Interactive comment on "Development of fragility curves for railway ballast and embankment scour due to overtopping flood flow" *by* R. Tsubaki et al.

Anonymous Referee 1

Figure 1 Presence of vortices over floodplain depicted using Line-Integral Convolution (LIC) visualization method. The direction of texture corresponds to the flow direction. The density of texture represents the magnitude of flow (unit discharge q).

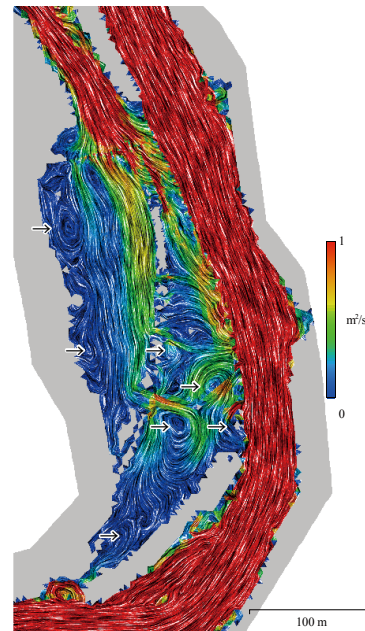
Comment 1-21: Line 252-254: where are these 2 locations in figure 3? What do the Author mean with presence of vortices over the floodplain?

Reply: Two locations were omitted by mistake and will be depicted in the revised manuscript. The vortices over the floodplain are shown in the plan-view figure 1 attached to this document. The sentence will be edited to be more detailed description of the flow situation.
